AAPM Comments QIBA CT: Lung Densitometry Profile

General Comments (from Coverletter): The implementation from the medical physicist and technologist perspective is technically complex and AAPM urges simplification where possible.

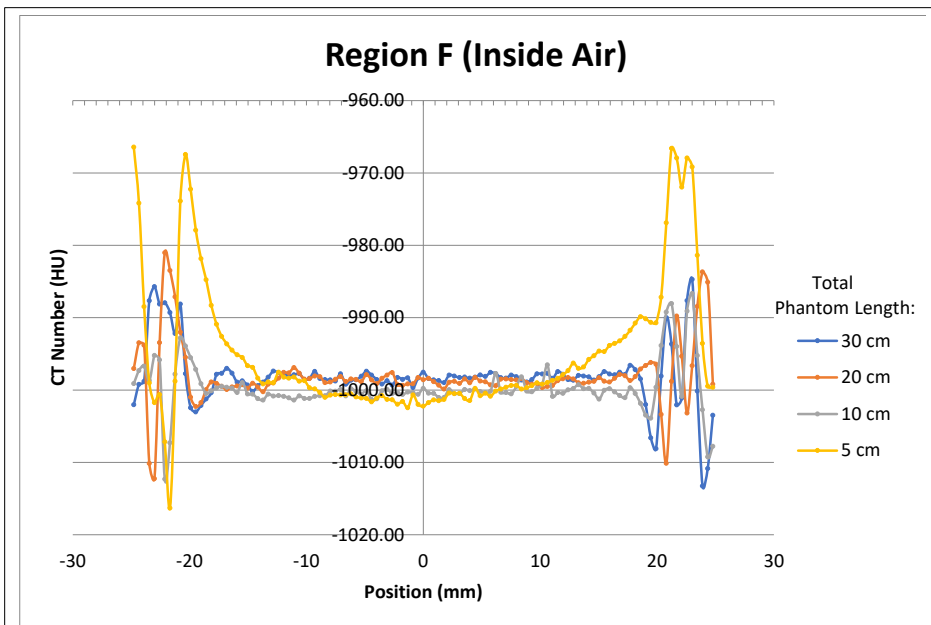
This phantom may lead to some issues with reverse cupping artifacts due to insufficient scattering material.

Response: The phantom is of limited width and ideally would have greater axial extent. However, we have used this phantom extensively for calibrations across active multi-center trials with consistent results. Moreover, we have investigated the impact of scatter on the HU value with and without attenuating material placed on either side of the standard COPD Gene phantom. The typical result in Air inside the phantom is plotted in **Figure A.1** below. Similar behavior is observed for all of the standard density measures. Nominally HU values measured within the central 5-10 mm of the phantom are accurate and not sufficiently impacted by scatter to be of concern for meeting the specifications of the profile. However, future designs of the phantom will take axial extent under consideration and add

additional water attenuating material of equivalent diameter on either side of the low density foam standards.
